STATE OF IDAHO
DEPARTMENT OF
ENVIRONMENTAL QUALITY

RE: Compliance Evaluation Inspection, US Ecology Idaho, Inc. (USEI) Site B
EPA ID No: IDD073114654

HWMA/RCRA COMPLIANCE INSPECTION REPORT

Facility: U.S. Ecology of Idaho – Site B (USEI-B)

Photo 1

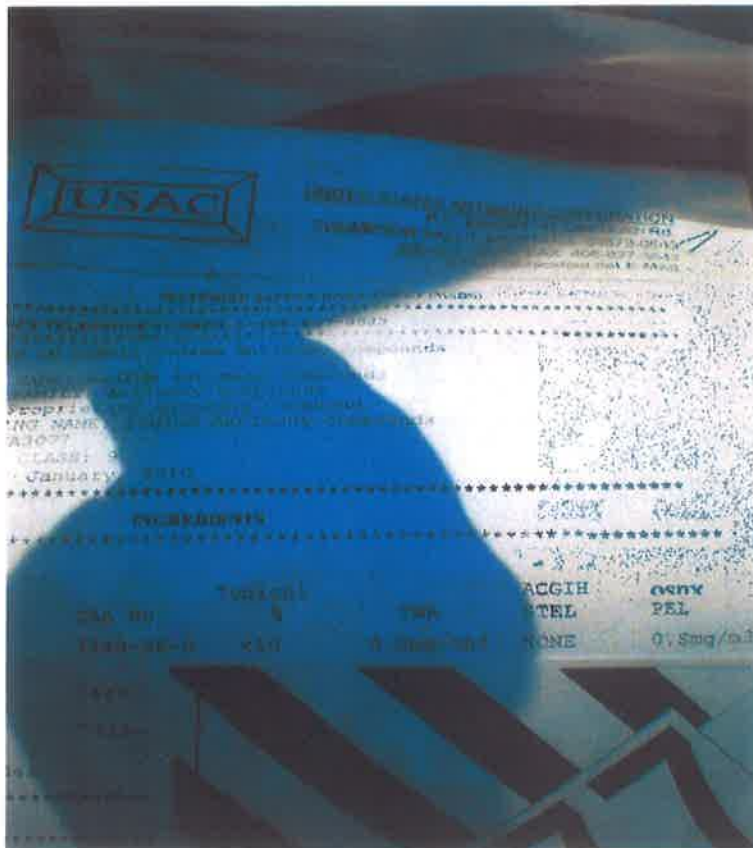
At the time of the inspection, Ms. Loerch and I observed 40 “super sack” containers of hazardous waste debris (D004, D008) generated by US Antimony (WO # 1310208696) (Photos 1 and 2). Three of the super sacks were observed to have leached a salt-like precipitate through the containers’ liner onto support pallets (Photos 3, 4, 6 and 7). Two of these containers were observed to have released waste onto the underlying ground surface (Photos 5 and 8) as well. We questioned whether inspection records indicated a discrepancy regarding packaging failure and what steps would be taken to address container integrity and waste releases.

Apparent violation: hazardous waste released from one US Antimony container onto ground surface in Container Storage Area 1(CSA 1) and failure to record the release on weekly CSA 1 inspection logs.

Immediately following the inspection on October 16, 2013, the facility began transferring the suspect US Antimony waste containers and associated cleanup material from CSA 1 to the Stabilization Building for treatment. According to Mr. Bailey, all of the US Antimony waste previously stored in CSA 1 was treated and disposed by November 1, 2013. Additionally, facility personnel responsible for conducting inspections at CSA 1 were provided refresher training on October 18, 2013.
